Engineering Support Application

*Number: 297**Issue: 1.00*

## Hardware Modification and Testing Procedures to enhance StrongARM / PC Card compatibility

*Figure 1: Location and configurations of R25 and R35 on the StrongARM Card*

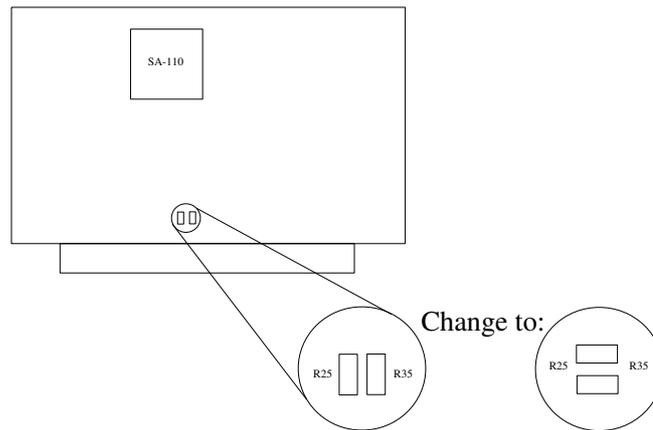
Locate resistors R25 and R35 on the CPU side of the StrongARM card. They should be mounted with their long axes perpendicular to the main connector on the card. Desolder them, and re-mount them on the same set of four pads with their main axes parallel to the card's main connector. As R25 and R35 have the same value, it is not important which resistor is mounted above which in the new arrangement. The unmodified and modified arrangements are illustrated in the figure below.

What this change actually does is insert one more ACT08 gate in the path of the MCLK signal from the CPU card connector to the SA-110; this causes MCLK as seen by the StrongARM to be delayed by 4ns relative to the pre-modification MCLK. This delay is best thought of as a phase skew on MCLK as propagated to StrongARM in order to more closely align the rising edge of NCLK with the stable data area on the data bus.

Figure 2: Location of C21, R26 and R35 on PC Card

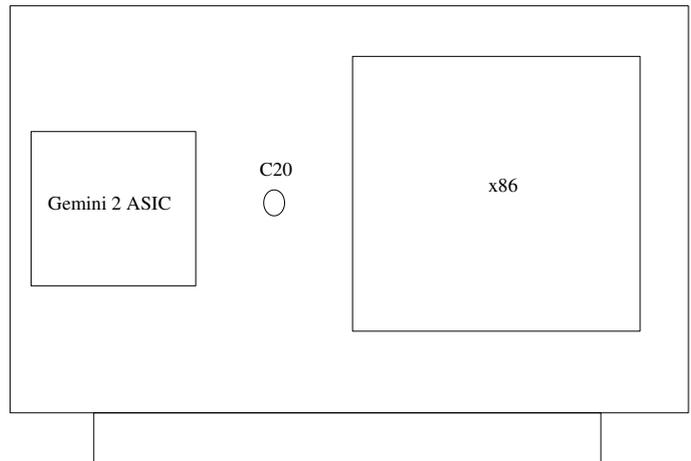
R35 changes from 560R to 680R

C21 changes from 22pF to 0R0

R26 changes from 0R0 to 56R

C20 changes to 33uF 10V size C low ESR
